#### **UNITARY PLAN UPDATE REQUEST MEMORANDUM**

**SUBJECT** Designation to be updated in the Auckland Unitary Plan

# Decision on an application to alter a designation under section 181(3) of the Resource Management Act 1991

**Designation number:** Designation 1714 (Designation 2500)

We consider that the detailed design as shown in the drawing 237531-0000-SKT-RU-0005 Rev A attached meet the intent of Condition 23, and that for consistency and accuracy the referenced drawings in Condition 23 should be updated to reflect the current detailed design.

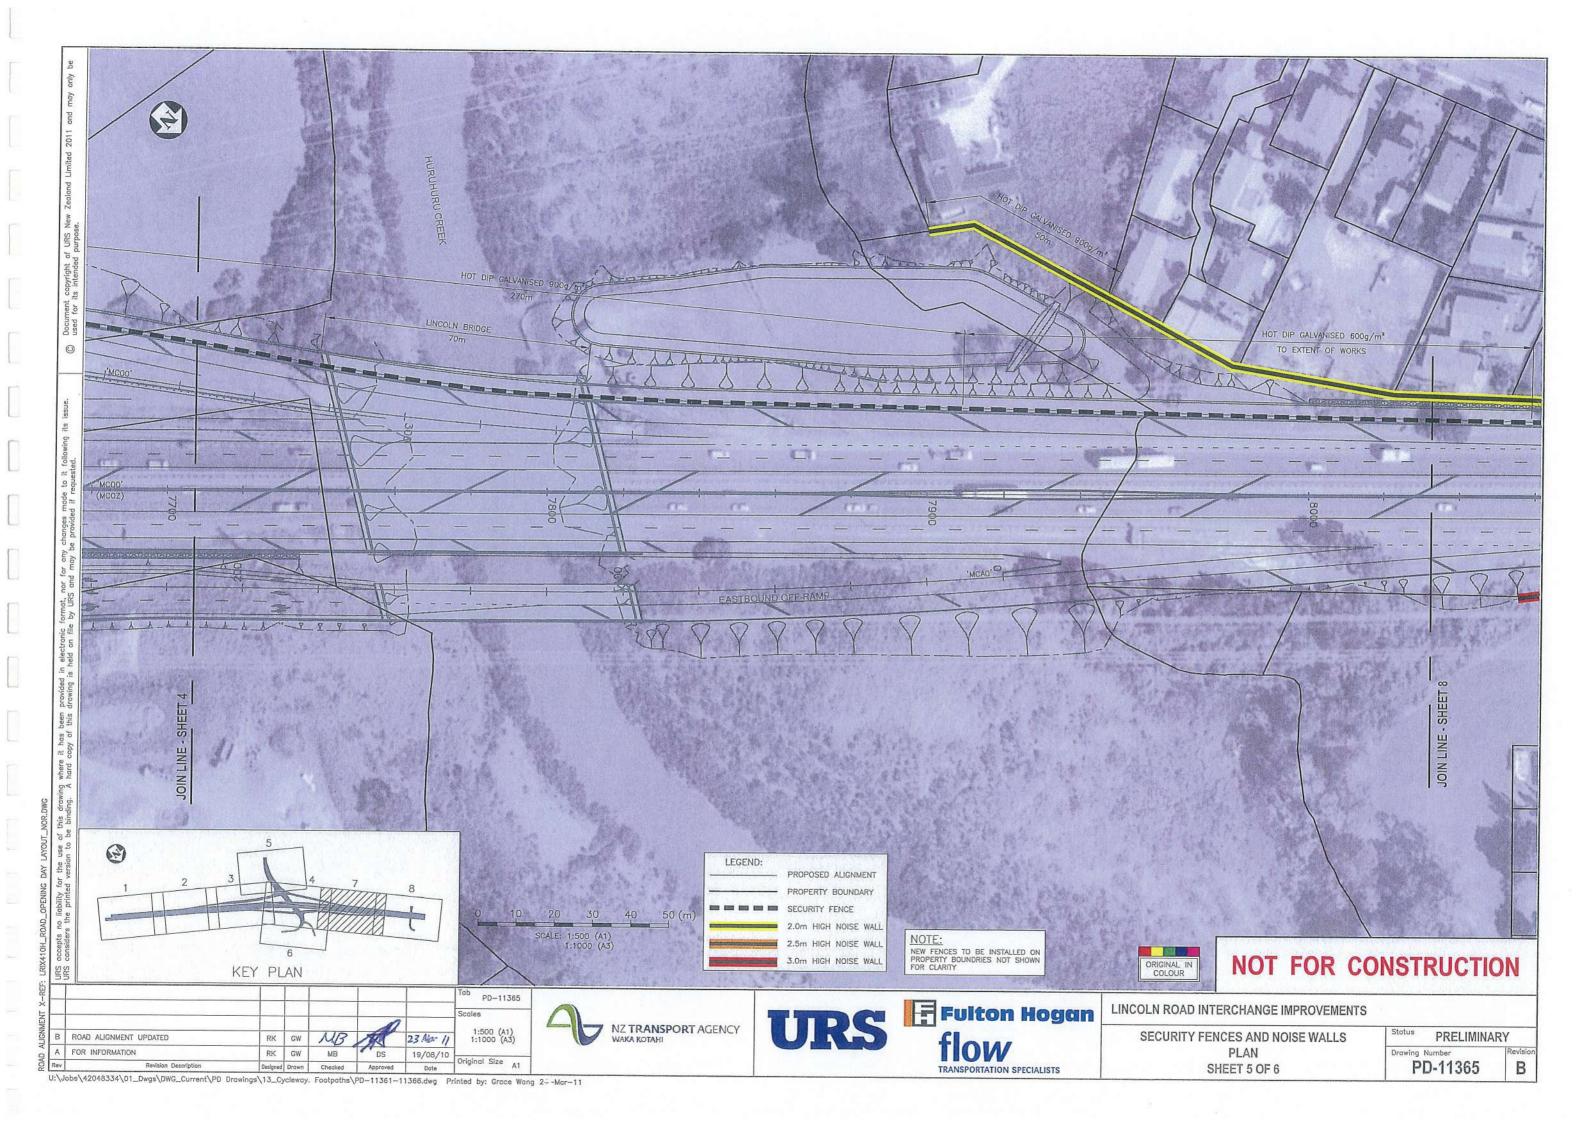
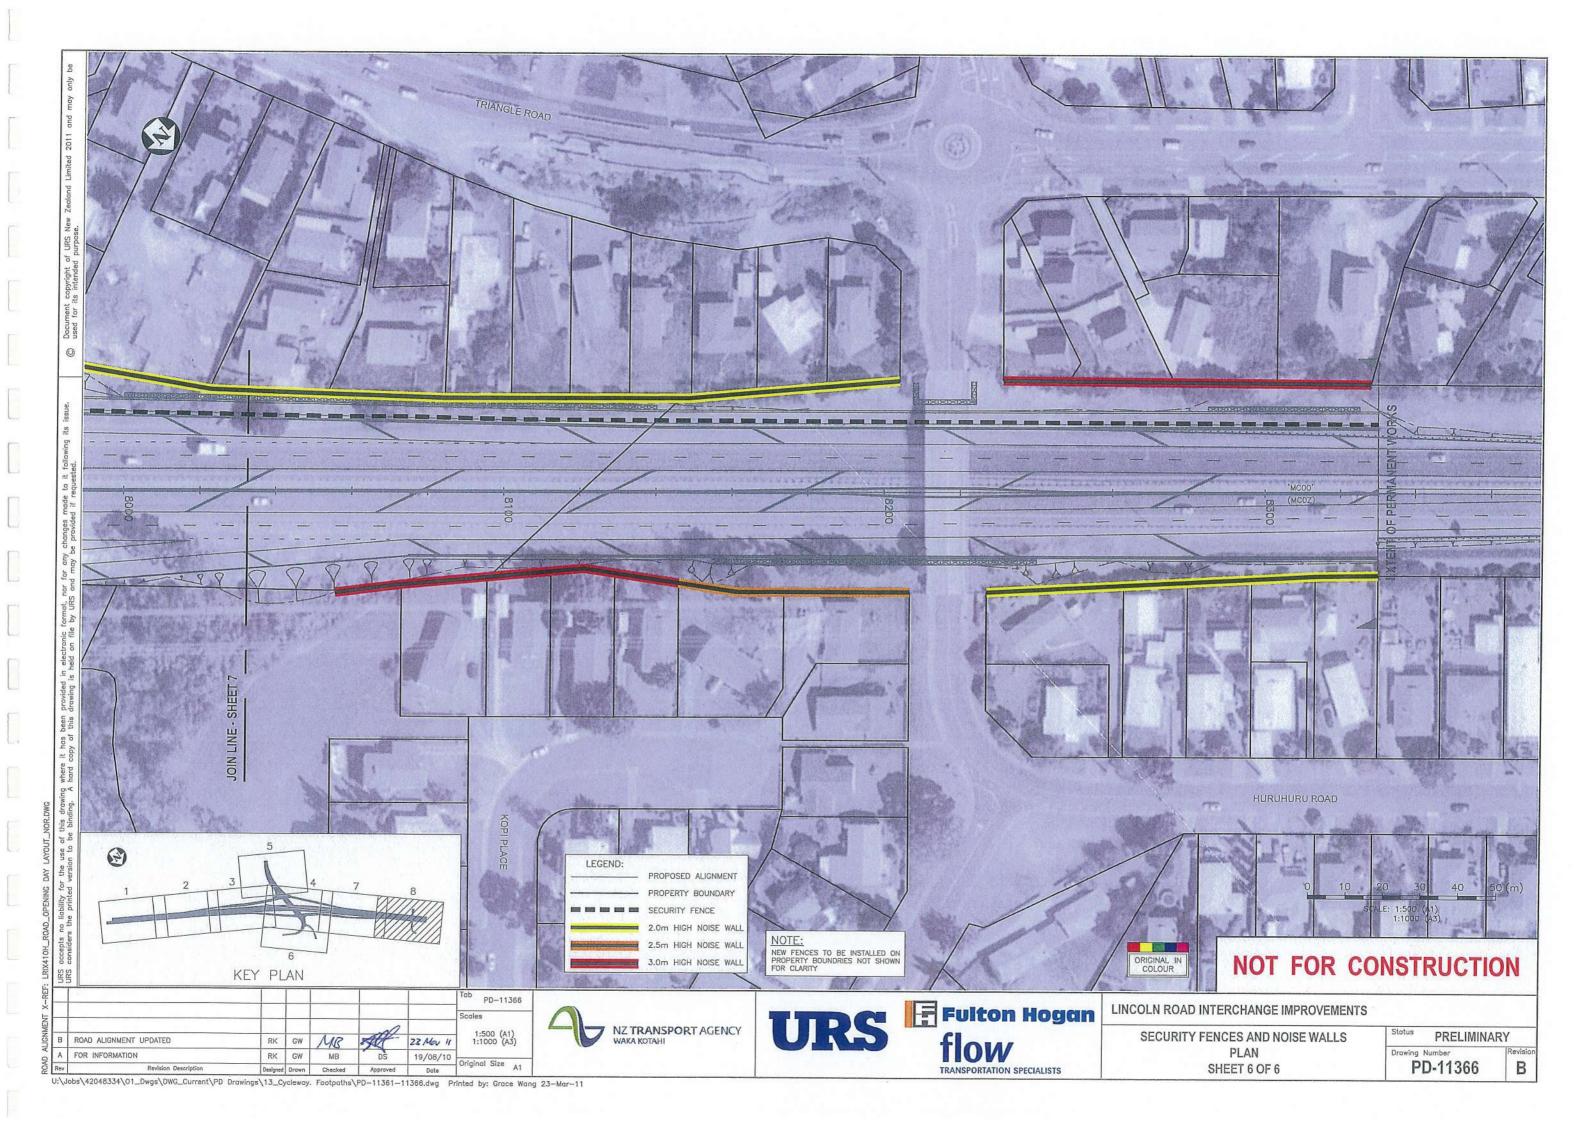
For the dwellings east of CH7950, noise modelling has shown that there is no change in noise level with or without the noise wall shown in drawing PD-11365 due to the topography of the adjacent sites and surrounds.

For the dwellings west of CH7950 the 2.0 m high noise walls shown in PD-11365 and 11366 do not meet the requirements of NZS6806. The detailed design has considered the appropriate height, location and length of the walls to comply with the requirements of NZS6806:2010.

Should Council consider this change acceptable, we recommend the following modification for Condition 23:

The operational noise emissions from State Highway 16 shall be managed in accordance with the recommendations of the noise and Vibration Technical Report submitted with the Notice of Requirement being Volume 3 of "Western Ring Route – SH16 Henderson Creek to Huruhuru Road Bridge". This management shall include the provision of noise mitigation for protected premises and facilities where necessary to comply with NZS6806:2010. Design details of operational noise mitigation barriers are to be designed in accordance with Plan PD11361 (Revision B), Plan PD11362 (Revision B), Plan PD11363 (Revision B), Plan PD11364 (Revision B) Plan PD11368 (Revision B), Plan 11366 (Revision B), Plan PD113637 (Revision A) and Plan PD11372 (Revision B). drawing 237531-0000-SKT-RU-0005 Rev A and drawings 237531-0000-DRG-RU-1201 to 1203 and 1211 to 1213.

**Proposed Drawings**

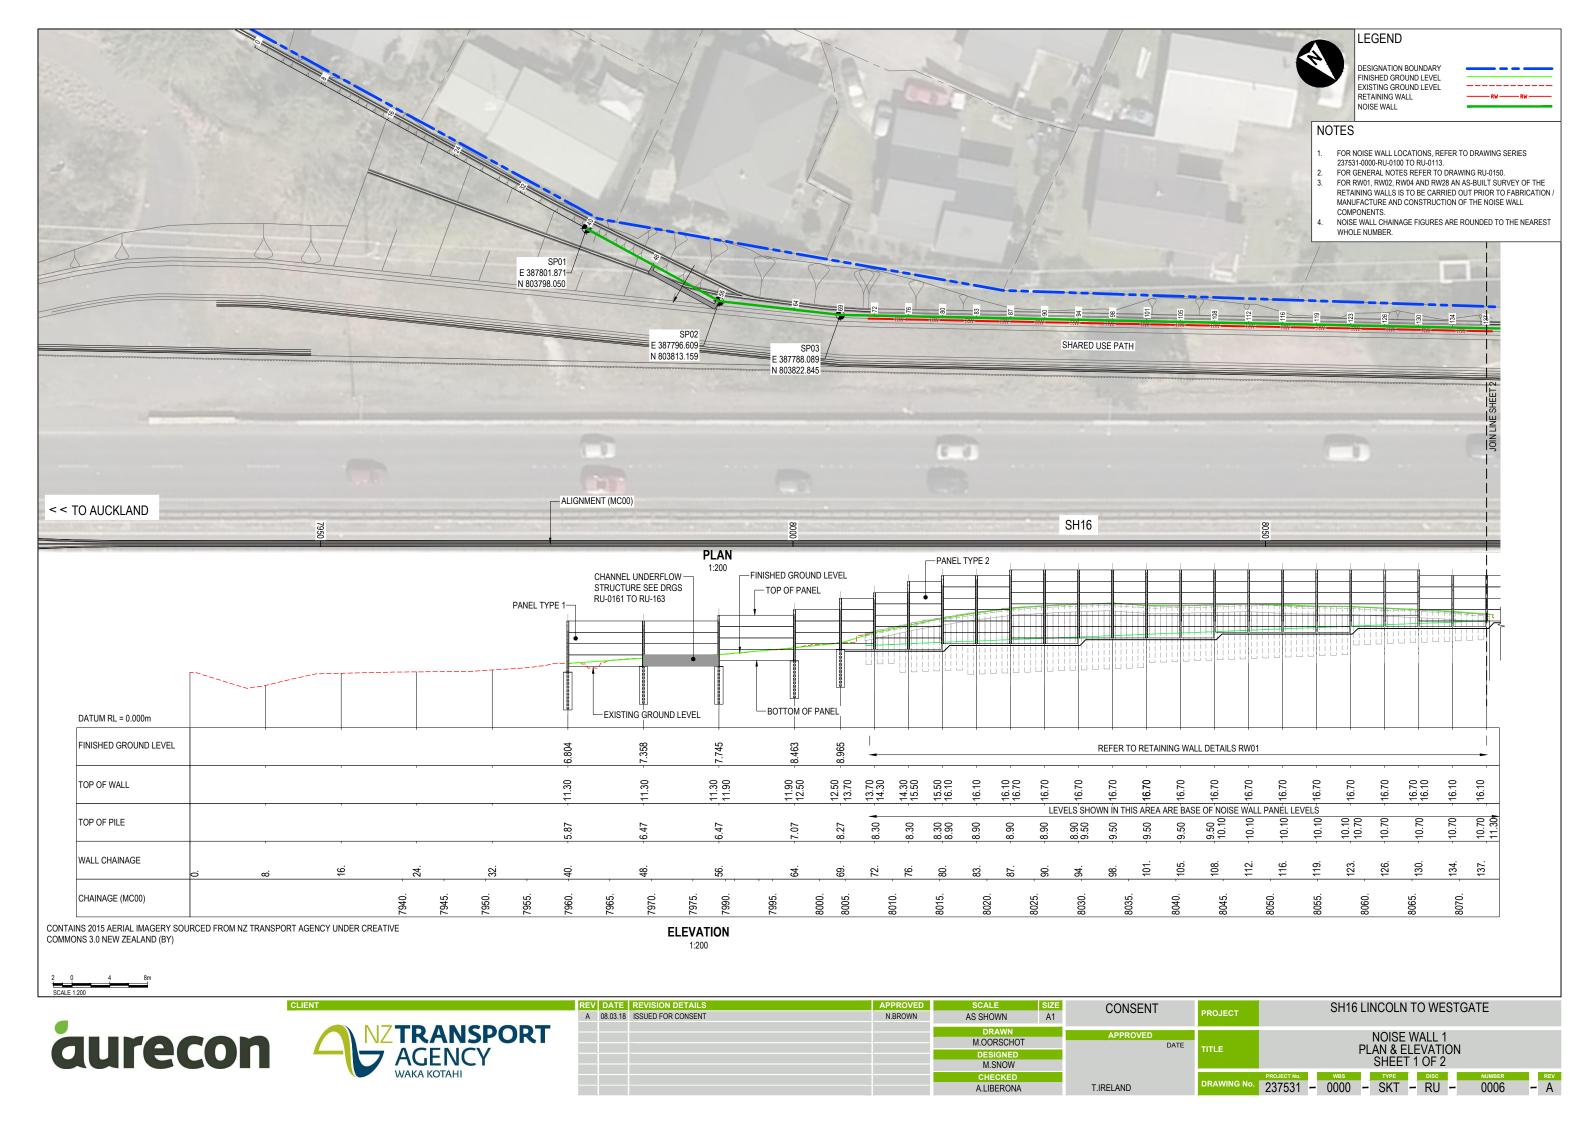
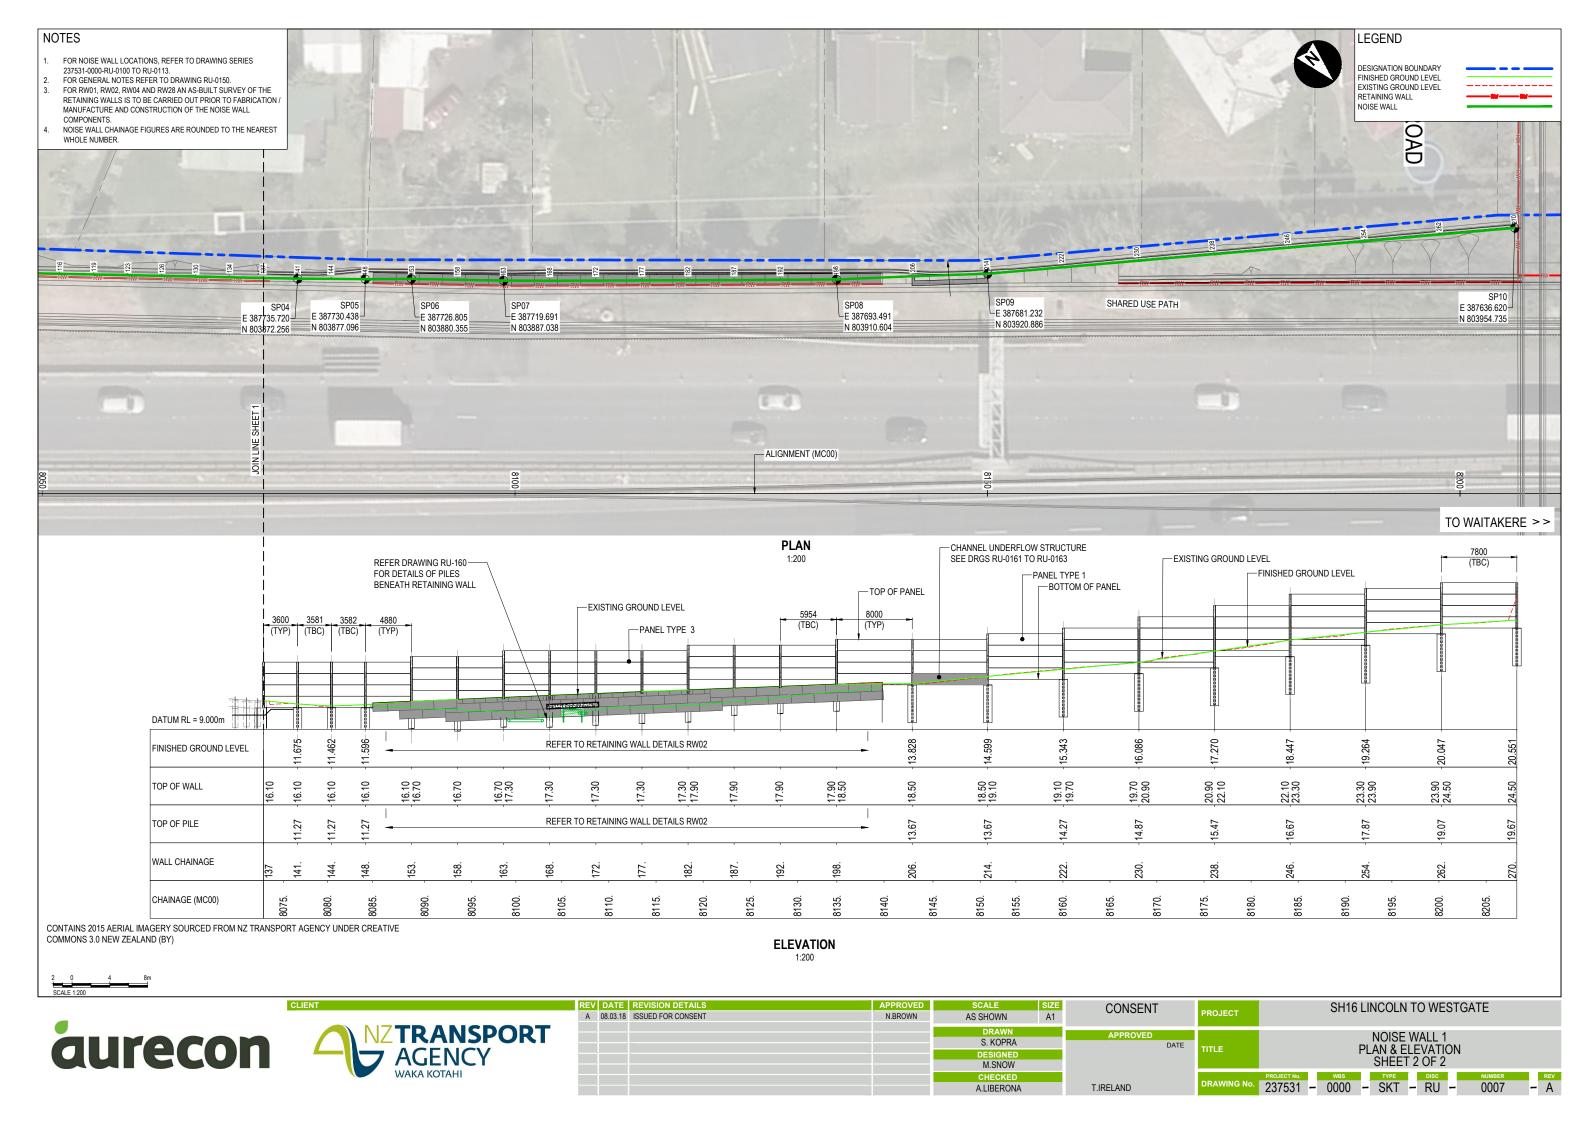
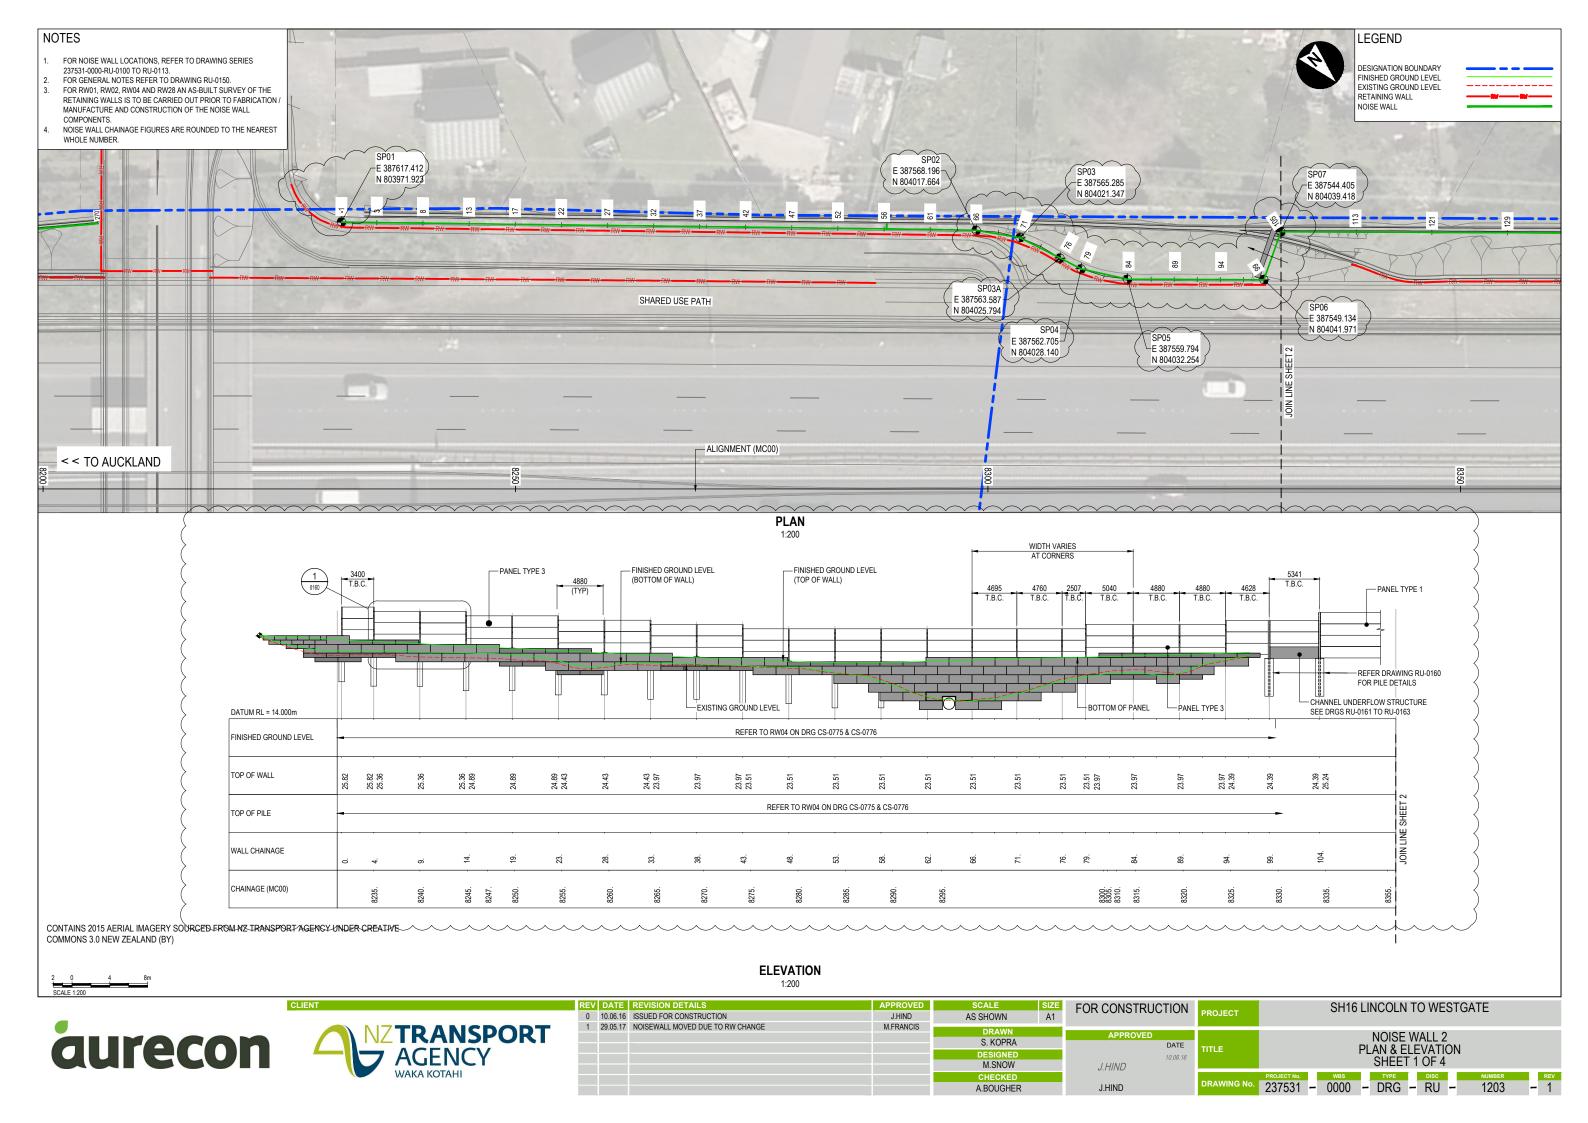
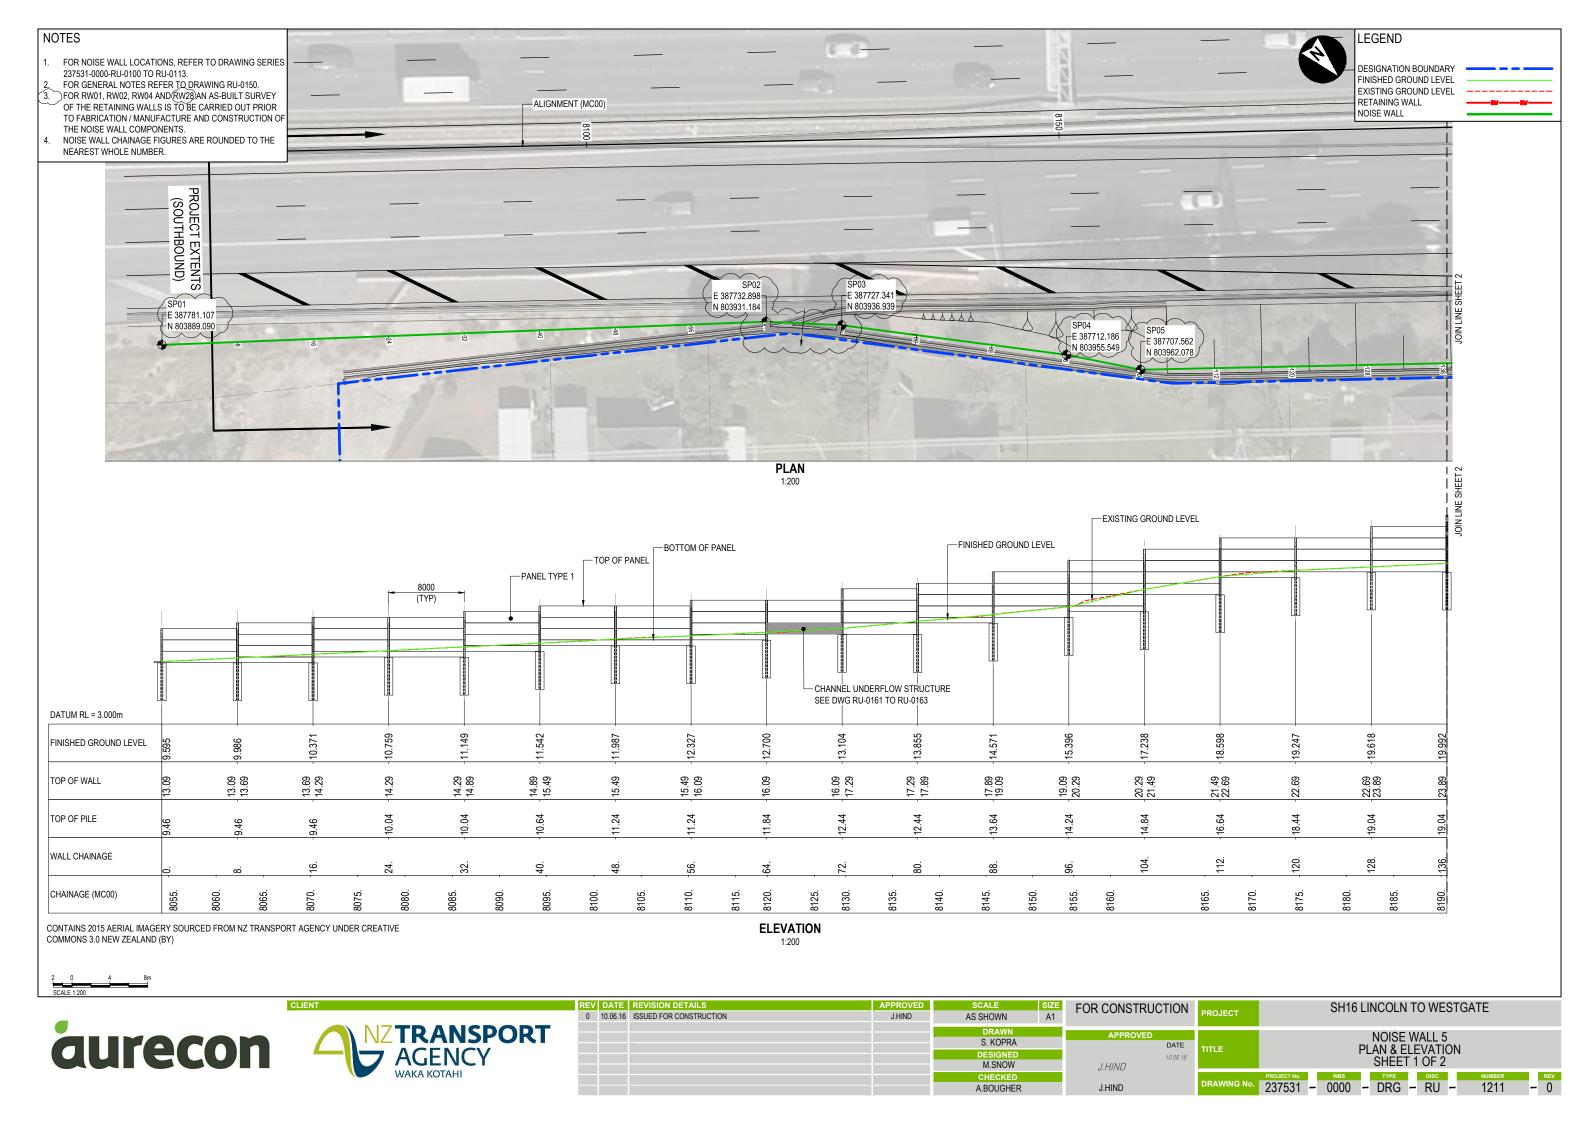
- Remove the requirement for construction of noise walls from the southern side of SH16 between approximately CH7900 and CH7950 (refer to drawing 237531-0000-SKT-RU-0005 Rev A);
- Enable construction of a 3.5m high noise wall (Noise Wall 1) on the southern side of SH16 from CH7950 to CH8200 (refer to drawings 237531-0000-SKT-RU-0006 Rev A & 0007 Rev A);
- Enable construction of a 3.0m high noise wall (Noise Wall 2) on the southern side of SH16 from Huruhuru Bridge to approximately CH8300 (refer to drawing 237531-0000-DRG-RU-1203 Rev 1);

- Enable construction of a 3.0m high noise wall (Noise Wall 5) on the northern side of SH16 from approximately CH8050 to CH8200 (refer to drawings 237531-0000-DRG-RU-1211 Rev 0 & 1212 Rev 0); and
- Enable construction of a 2.5m high noise wall (Noise Wall 6) on the northern side of SH16 from approximately CH8200 to CH8300 (refer to drawing 237531-0000-DRG-RU-1213 Rev 0).

the provision of noise mitigation for protected premises and facilities where necessary to comply with NZS6806:2010. Design details of operational noise mitigation barriers are to be designed in accordance with Plan PD11361 (Revision B), Plan PD11362 (Revision B), Plan PD11363 (Revision B), Plan PD11364 (Revision B), <u>drawings</u> 237531-0000-SKT-RU-0005 to 0007 Rev A and drawings 237531-0000-DRG-RU-1203 Rev 1 and 1211 to 1213 Rev 0.
